Product Change Notice (PCN)

Subject: Wafer-fabrication and chip-assembly factories addition for RL78/G23 QFN and LQFP package products

Publication Date: 6/30/2025

7mm×7mm 0.8mm pitch 32pin LQFP Package Outline (BJ)

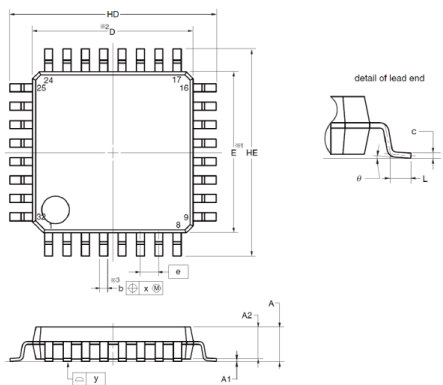
Comparison: 7mm×7mm 0.8mm pitch 32pin LQFP package

Greatek package symbols comply JEDEC standard.

Greatek Symbol	7x7mm 32pin LQFP PLQP0032GE-A			BJ Symbol	7x7mm 32pin LQFP PLQP0032GB-A		
	Dimension in Millimeters				Dimension in Millimeters		
	Min	Nom	Max		Min	Nom	Max
A	-	-	1.60	A	-	-	1.70
A1	0.05	-	0.15	A1	0.00	0.10	0.20
A2	1.35	1.40	1.45	A2	-	1.40	-
D	-	9.00	-	HD	8.80	9.00	9.20
D1	-	7.00	-	D	6.90	7.00	7.10
E	-	9.00	-	HE	8.80	9.00	9.20
E1	-	7.00	-	E	6.90	7.00	7.10
N	-	32	-	-	-	-	-
e	-	0.80	-	e	-	0.80	-
b	0.30	0.37	0.45	b	0.32	0.37	0.42
c	0.09	-	0.20	c	0.09	0.145	0.20
θ	0°	3.5°	7°	θ	0°	-	8°
L	0.45	0.60	0.75	L	0.30	0.50	0.70
L1	-	1.00	-	-	-	-	-
aaa	-	-	0.20	-	-	-	-
bbb	-	-	0.20	-	-	-	-
ccc	-	-	0.10	y	-	0.10	-
ddd	-	-	0.20	x	-	0.20	-

44pin_LQFP
10mm×10mm 0.8mm pitch 44pin LQFP Package Outline (Greatek)

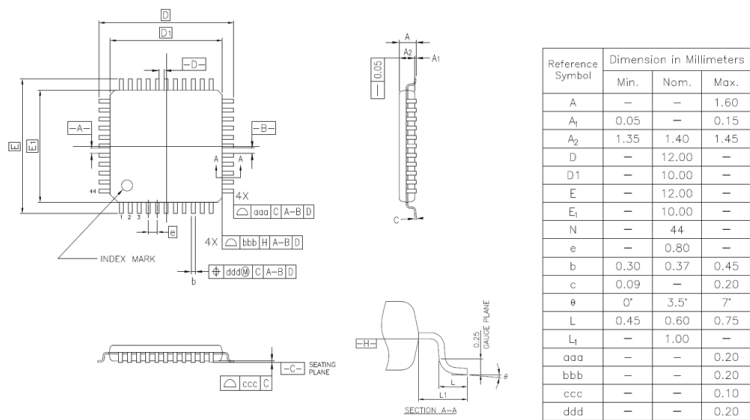
10x10mm 0.8mm pitch 44pin LQFP Marking specification

*Difference for 10x10mm 0.8mm pitch 44pin LQFP package only.

Product	Greatek (Addition)	KL (Existing)
Blank ROM		
	1st row - 2nd row 7-digit product name 3rd row 7-digit Lot No.	1st row 7-digit product name 2nd row - 3rd row 9-digit Lot No.

64pin_LQFP
10mm×10mm 0.5mm pitch 64pin LFQFP Package Outline (Greatek)

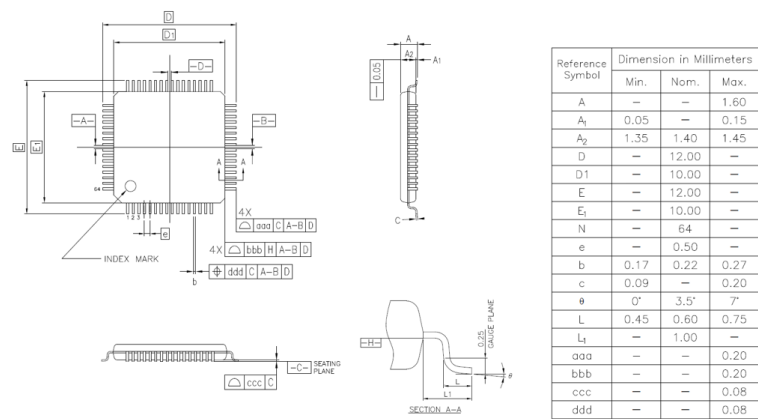
Comparison: 10mm×10mm 0.5mm pitch 64pin LFQFP package

Greatek package symbols comply JEDEC standard.

Greatek Symbol	10x10mm 64pin LQFP PLQP0064KL-A			BJ Symbol	10x10mm 64pin LQFP PLQP0064KB-C		
	Dimension in Millimeters				Dimension in Millimeters		
	Min	Nom	Max		Min	Nom	Max
A	-	-	1.60	A	-	-	1.70
A1	0.05	-	0.15	A1	0.05	-	0.15
A2	1.35	1.40	1.45	A2	-	1.40	-
D	-	12.00	-	HD	11.80	12.00	12.20
D1	-	10.00	-	D	9.90	10.00	10.10
E	-	12.00	-	HE	11.80	12.00	12.20
E1	-	10.00	-	E	9.90	10.00	10.10
N	-	64	-	-	-	-	-
e	-	0.50	-	e	-	0.50	-
b	0.17	0.22	0.27	bp	0.15	0.20	0.27
c	0.09	-	0.20	c	0.09	-	0.20
θ	0°	3.5°	7°	θ	0°	3.5°	8°
L	0.45	0.60	0.75	Lp	0.45	0.60	0.75
L1	-	1.00	-	L1	-	1.000	-
aaa	-	-	0.20	-	-	-	-
bbb	-	-	0.20	-	-	-	-
ccc	-	-	0.08	y	-	-	0.08
ddd	-	-	0.08	x	-	-	0.08

80pin_LQFP
12mm×12mm 0.5mm pitch 80pin LFQFP Package Outline (Greatek)

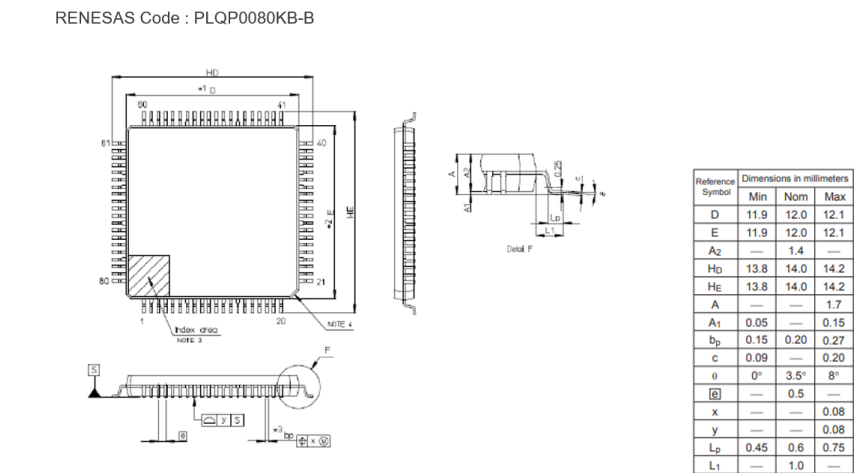
Comparison: 12mm×12mm 0.5mm pitch 80pin LFQFP package

Greatek package symbols comply JEDEC standard.

Greatek Symbol	12x12mm 80pin LQFP PLQP0080KJ-A			BJ Symbol	12x12mm 80pin LQFP PLQP0080KB-B		
	Dimension in Millimeters				Dimension in Millimeters		
	Min	Nom	Max		Min	Nom	Max
A	-	-	1.60	A	-	-	1.70
A1	0.05	-	0.15	A1	0.05	-	0.15
A2	1.35	1.40	1.45	A2	-	1.40	-
D	-	14.00	-	HD	13.80	14.00	14.20
D1	-	12.00	-	D	11.90	12.00	12.10
E	-	14.00	-	HE	13.80	14.00	14.20
E1	-	12.00	-	E	11.90	12.00	12.10
N	-	80	-	-	-	-	-
e	-	0.50	-	e	-	0.50	-
b	0.17	0.22	0.27	bp	0.15	0.20	0.27
c	0.09	-	0.20	c	0.09	-	0.20
θ	0°	3.5°	7°	θ	0°	3.5°	8°
L	0.45	0.60	0.75	Lp	0.45	0.60	0.75
L1	-	1.00	-	L1	-	1.000	-
aaa	-	-	0.20	-	-	-	-
bbb	-	-	0.20	-	-	-	-
ccc	-	-	0.08	y	-	-	0.08
ddd	-	-	0.08	x	-	-	0.08
